APPLICATION NUMBER: RECON 25/0741

PROPOSAL: CONSTRUCTION OF STABLE BLOCK, ALTERATIONS TO ACCESS AND ECOLOGICAL ENHANCEMENTS

SITE: Land north of and adjacent to St Mary's Church, Church Lane Marshfield Cardiff

REVISION REQUIRED TO EARTH BANKS AND PLANTING PROPOSALS

An updated Site Plan 03A by Hayston Developments & Planning Ltd has been submitted.

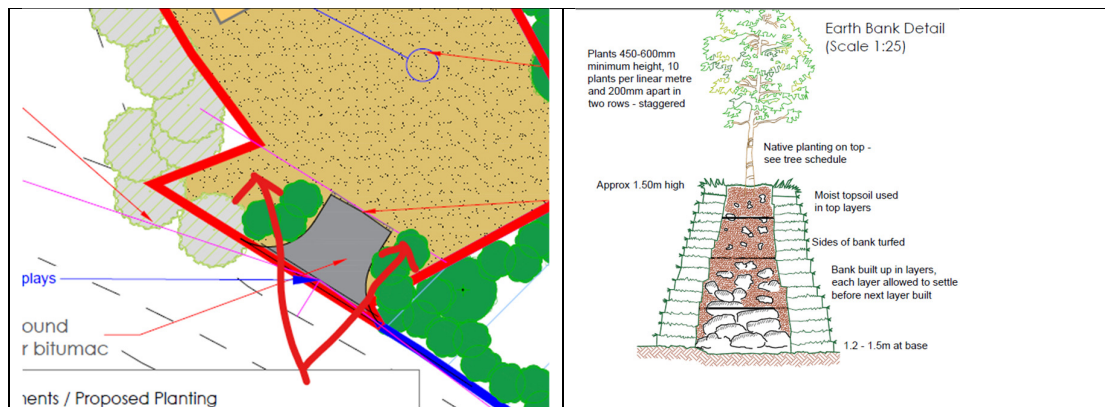
Visibility splays are now shown – this confirms an opportunity for hedge planting along the site frontage onto Church Lane as looking north the stables will be open to views, parked vehicles will also be open to view in particular as parking is not defined.

It is not clear why the hard surface areas highlighted below are proposed, ideally these would be soft landscape with hedges, trees, grass which would restrict parking/storage etc away from the frontage.
